Change Record

Contract Number 008625	Contract Title SR 520 West Approach Bridge North Project	Federal Aid Number BR-NHPP-0520(053)
Change Order Number 116	Change Description RSUP Lighting Mod	Date Oct 11, 2017
Region Northwest Region	Project Engineer Stephen Strand	Phone Number (206) 770-3565
Prime Contractor / Design-Builder Flatiron West, Inc.

CONTRACT NO: 008625 FEDERAL AID NO: ER-NHPP-0520 (053)
 CONTRACT TITLE: SR 520, MONTLAKE TO EVERGREEN PT. BRIDGE WEST APPR
 CHANGE ORDER NO: 116 RSUP LIGHTING MOD

This change order makes the following modifications to the illumination system for the Regional Shared Use Path (RSUP):

SR 520 FILE NO. 7051 SHEET WR45 Projectwise Vault

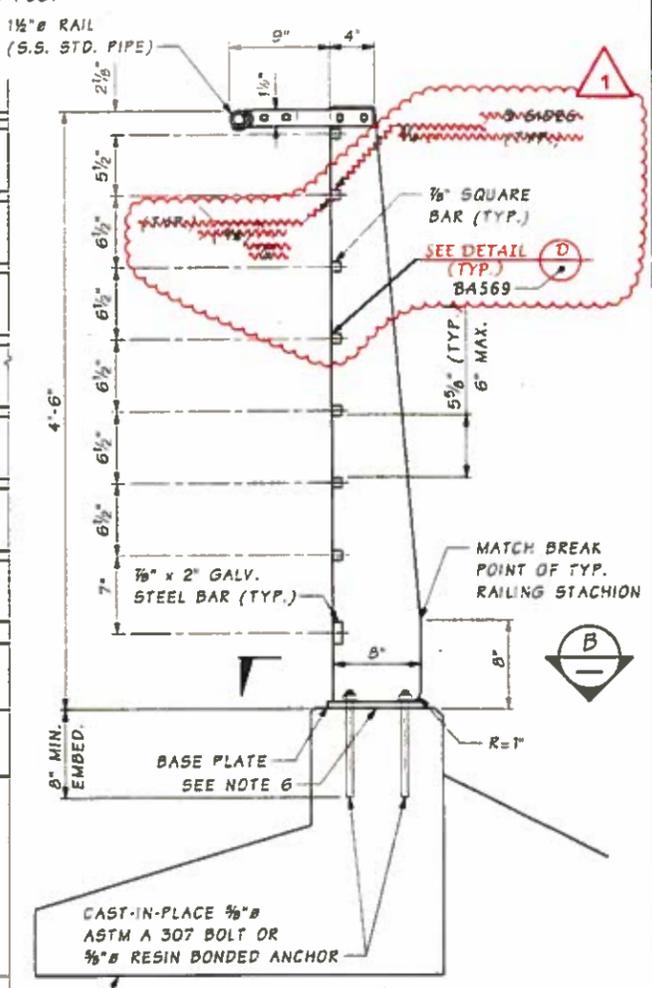
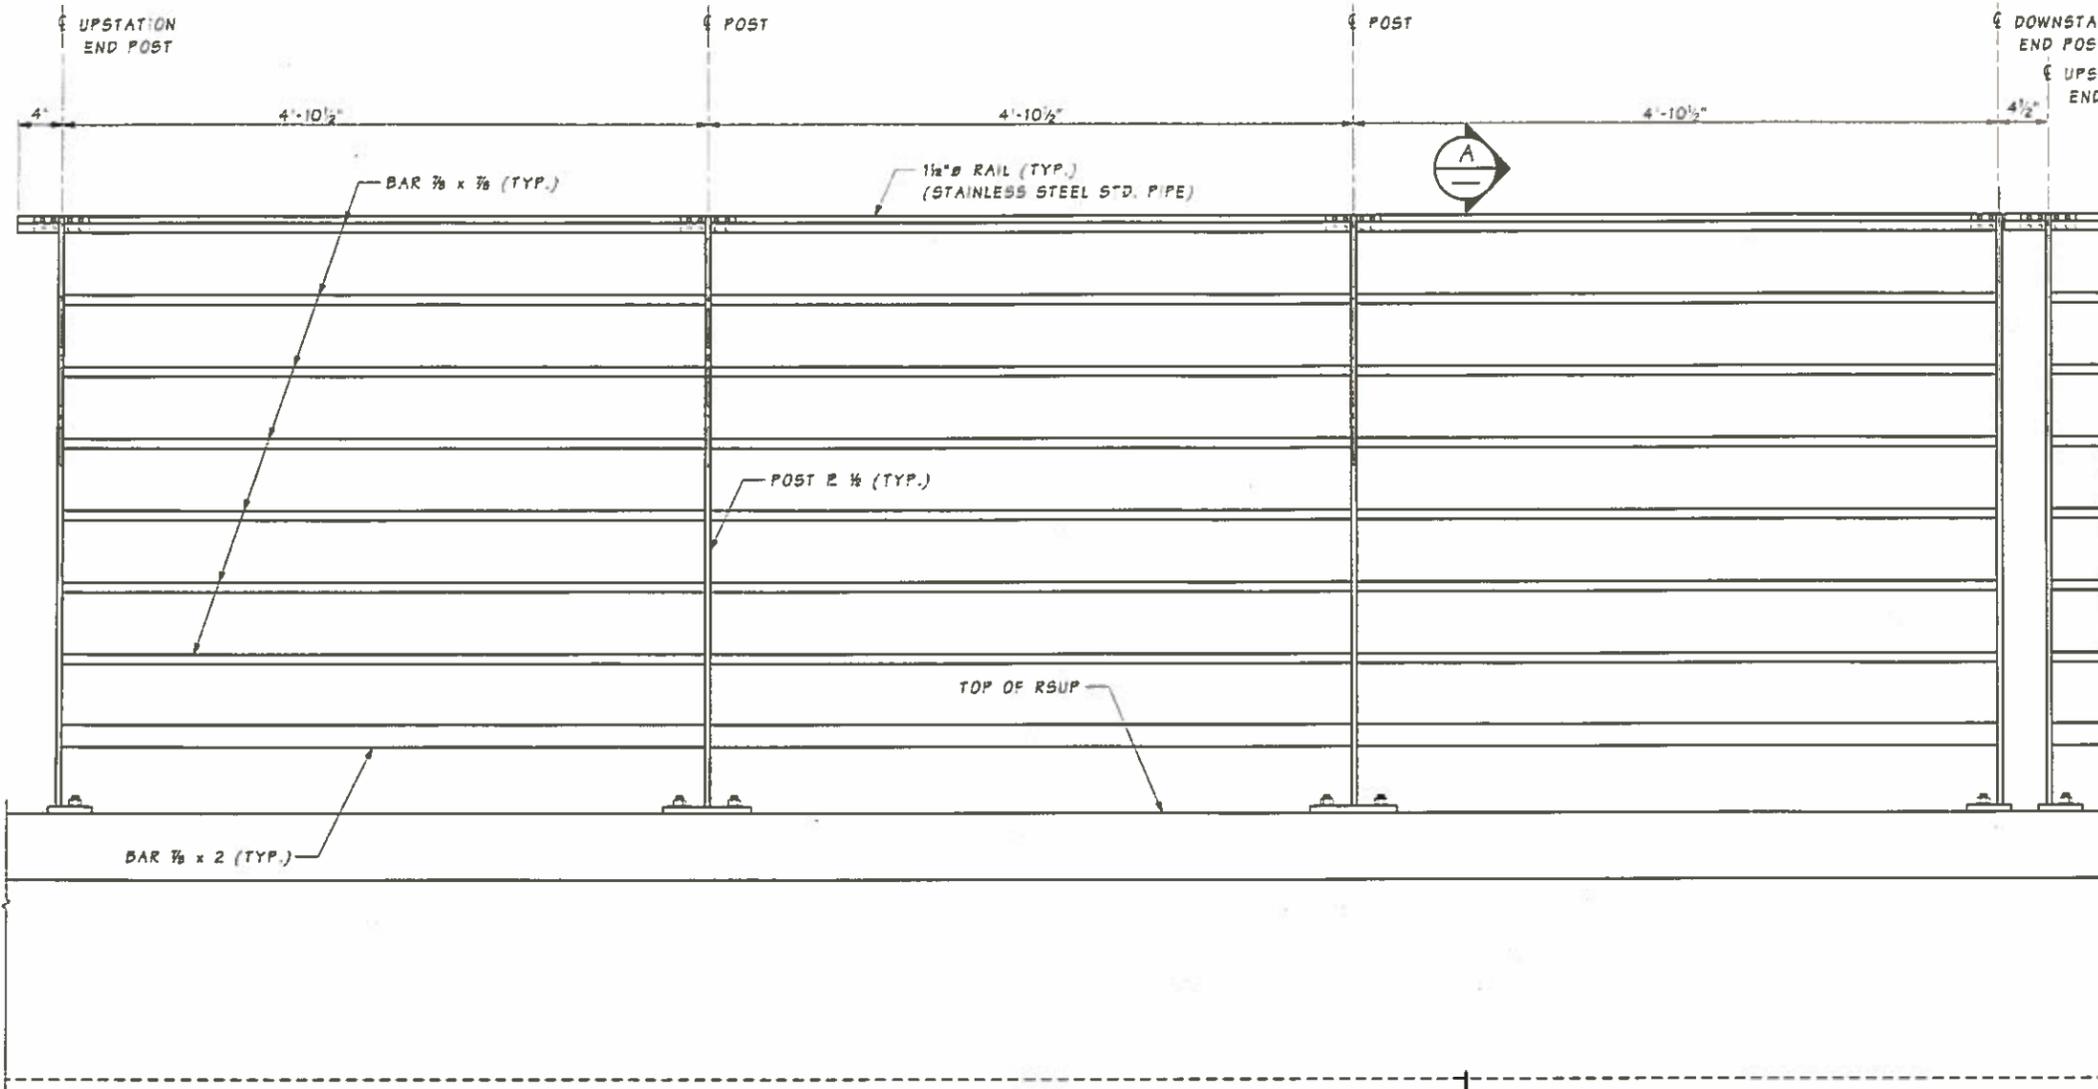
- Plan sheet WR45 titled "Bridge Railing Type Moment Slab Ped. Details"

PLAN REF. NO.
ILD11
SHEET
607
OF
1797
SHEETS

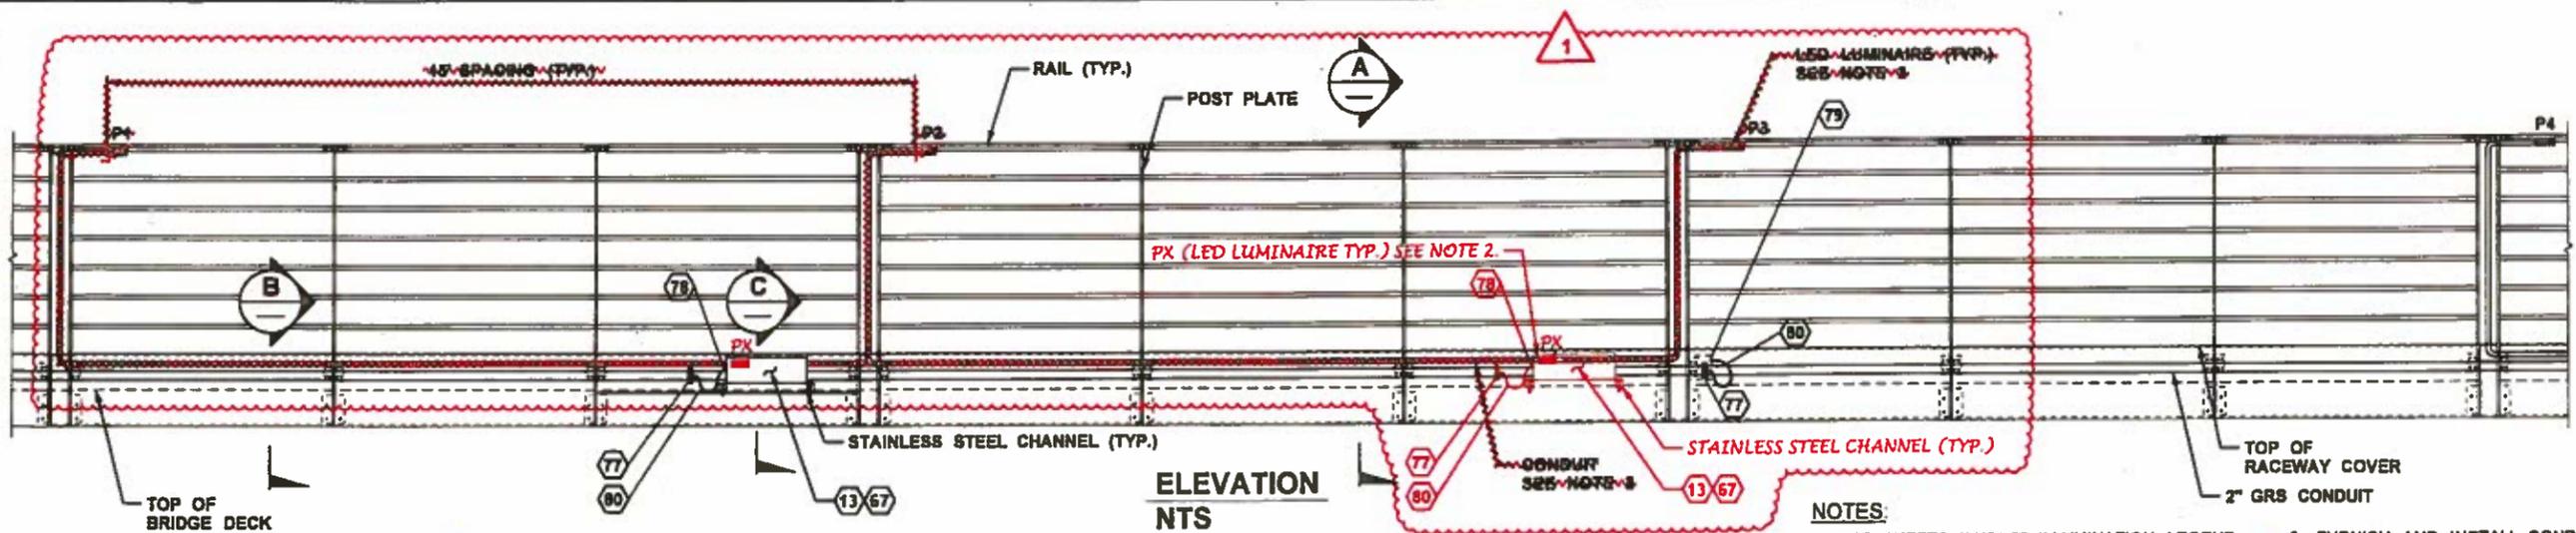
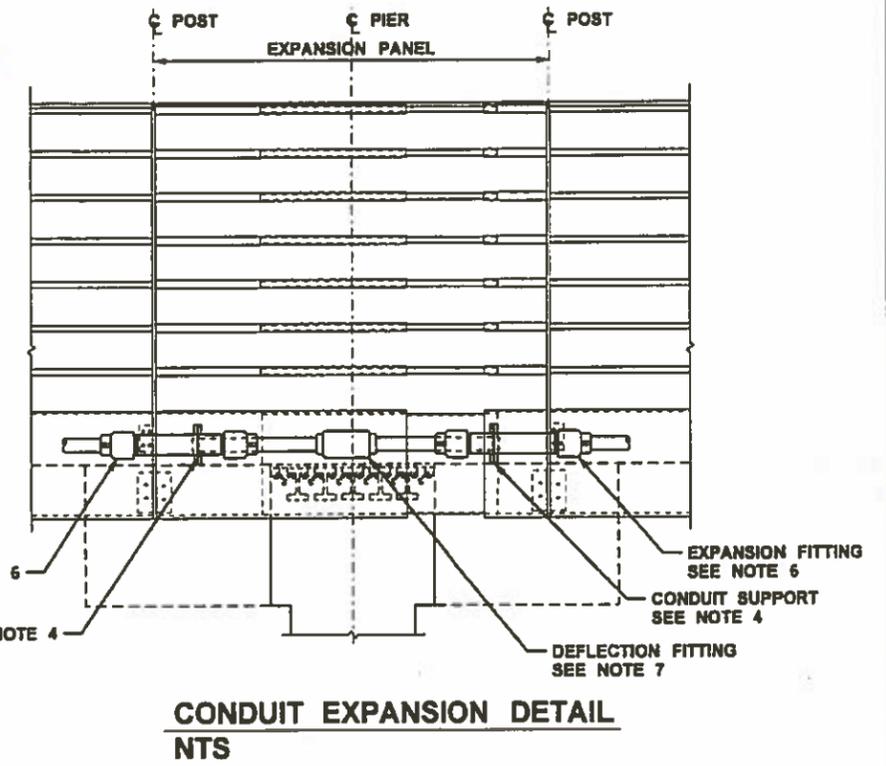
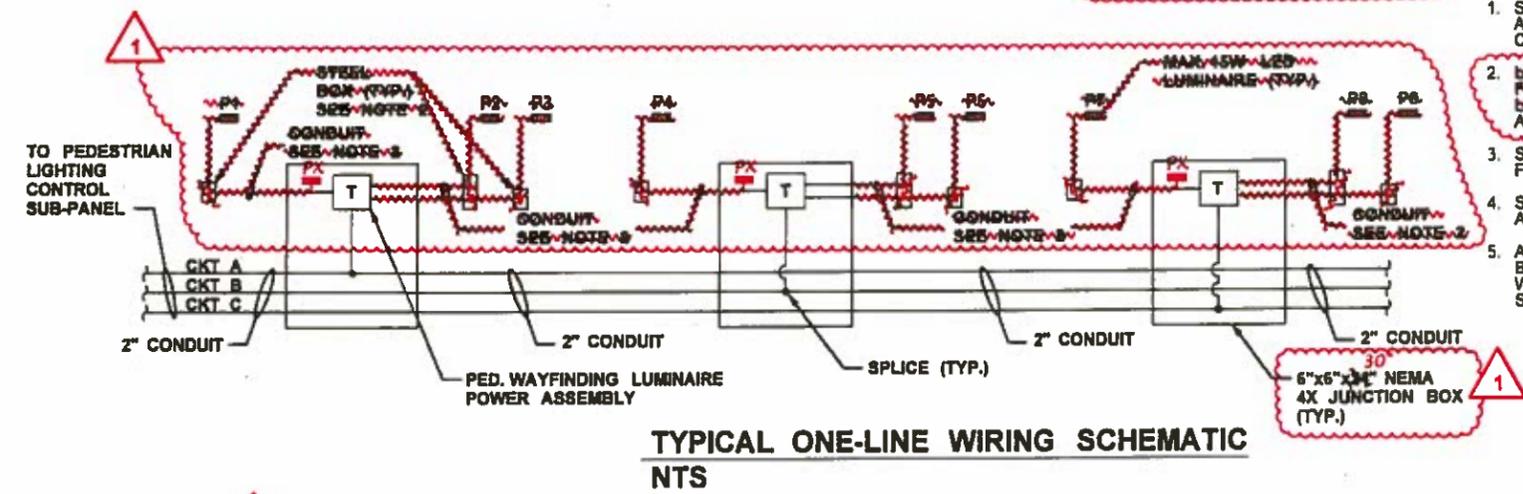
- Plans sheet IID13a, IID13b and IID13c all titled " Illumination Details"
